UNITED STATES PATENT AND TRADEMARK OFFICE

APPLICATION NO.	FILING DATE	FIRST NAMED INVENTOR	ATTORNEY DOCKET NO.	CONFIRMATION NO.
09/898,806	07/03/2001	Koki Kanda	0941.65658	5709

Office Action Summary

DETAILED ACTION

FIGURE 3

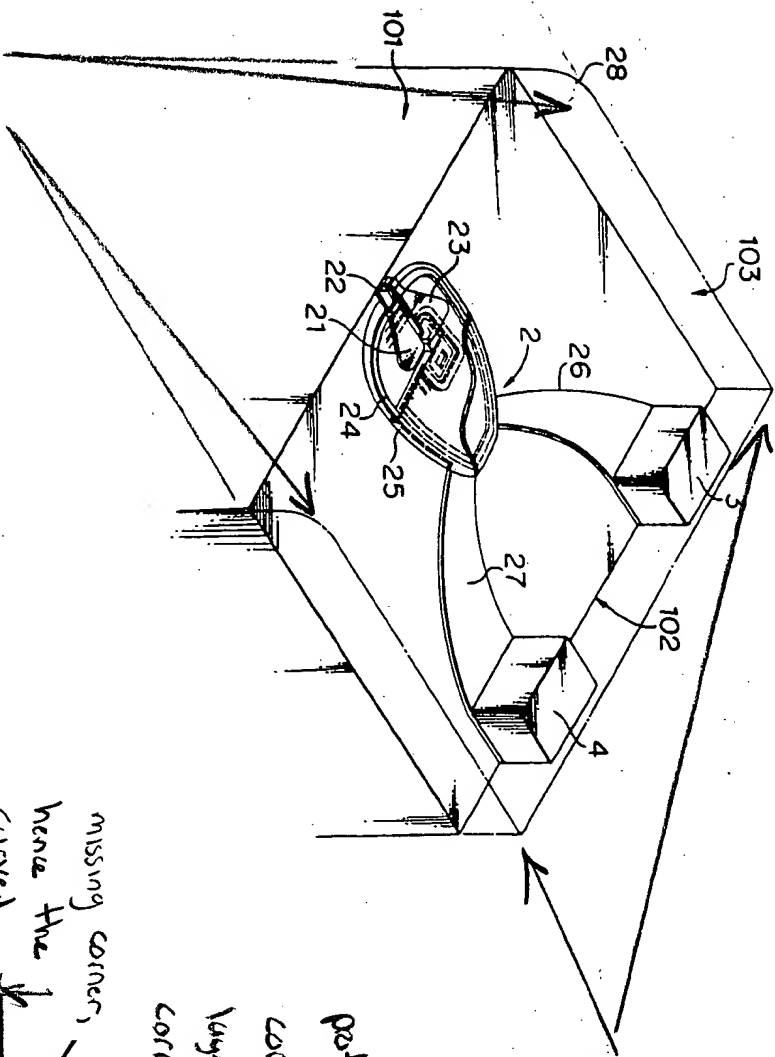
Alternatively, as indicated in the enclosed marked-up copy of Figures 2 and 3 of Matsuzaki (US 5,200,869) appended herewith, the recess could be broadly considered that portion of (28) into which upper pole (23) of the thin-film element protrudes.

missing corner,
hence the
curved
surface
at
this
intersection of
layer 28 is recessed away from a square corner,
unlike the non-recessed top corners.

Alternatively,
the layer 28
can be considered
"recessed" to
accommodate upper
pole 23

FIGURE 2

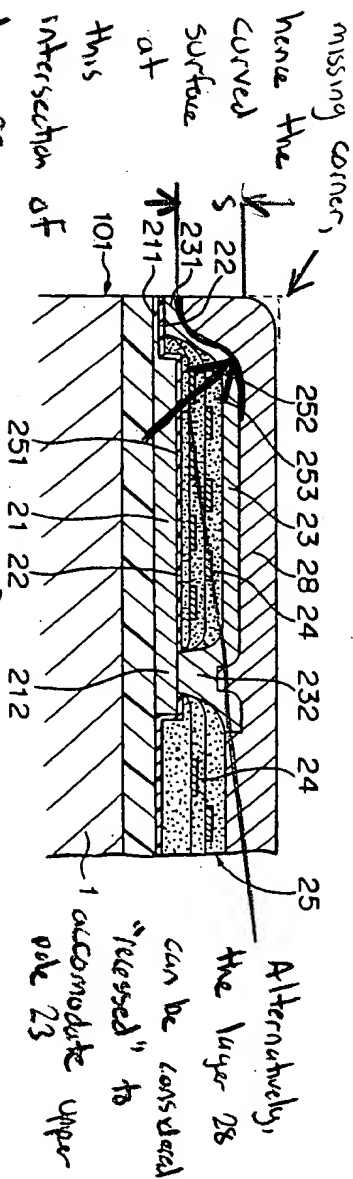
More concretely, as shown in the enclosed marked-up copy of Figures 2 and 3 of Matsuzaki (US 5,200,869) appended herewith, the recess is considered to be the portion of (28) which is missing from the protective portion (28) at the intersection of surfaces (101) and the end surface of the distal end of protective layer (28). The missing corner of surface (28) at this intersection is considered to be recessed away from the right-angled square corner, as is often done in the prior art to minimize chipping at the trailing end air bearing surface of the slider. Note that the non-ABS surface forms a square, right-angled corners.

rounded corner "recessed" into 28
is formed the entire width
of slider rail 101

non-recessed corners of protective layer 28

protective layer 28 is recessed away from
corner intersection of the distal end of protective
layer 28 and surface 101 forming a rounded
corner
